DEVELOPMENT REVIEW COMMITTEE (DRC) COMMENT REPORT

PROJECT NAME: 525 S. Andrews Avenue

CASE NUMBER: UDP-S21010

REQUEST: Site Plan Level II Review: 399 Residential Units, 900 Square Feet of Commercial Use in Downtown Regional Activity Center

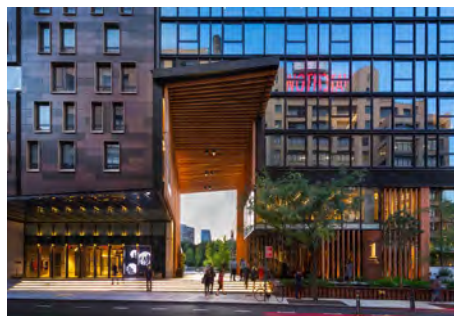
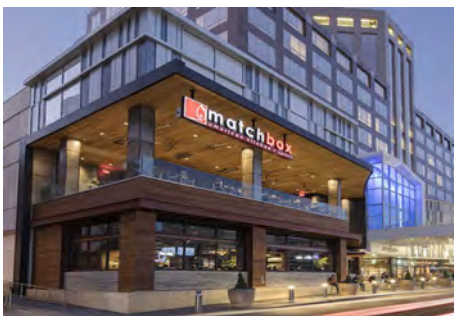
- h. As proposed, the top of the tower does not meet the design requirements for expressive and sculptural tower top design nor does the top of the tower add to the overall skyline composition. The design needs to be re-evaluated to meet this requirement. Refer to images below for examples.
- i. Parking podium should contain exceptional design solutions to screen the podium through various design techniques and materials on the south elevation.

- 9) The proposed lower levels of the building, pedestrian scale levels, should be redesigned to incorporate double story height the full length of the building street frontages. Building corners should contain significant architectural features that are proportionate to the overall project scale with significant projections, change in material, and other design techniques. The existing approved site plan for this property, DRC Case R17025, contained extensive architectural enhancements along the pedestrian level and should be referencing when addressing this comment. In addition, the images below are other design examples.
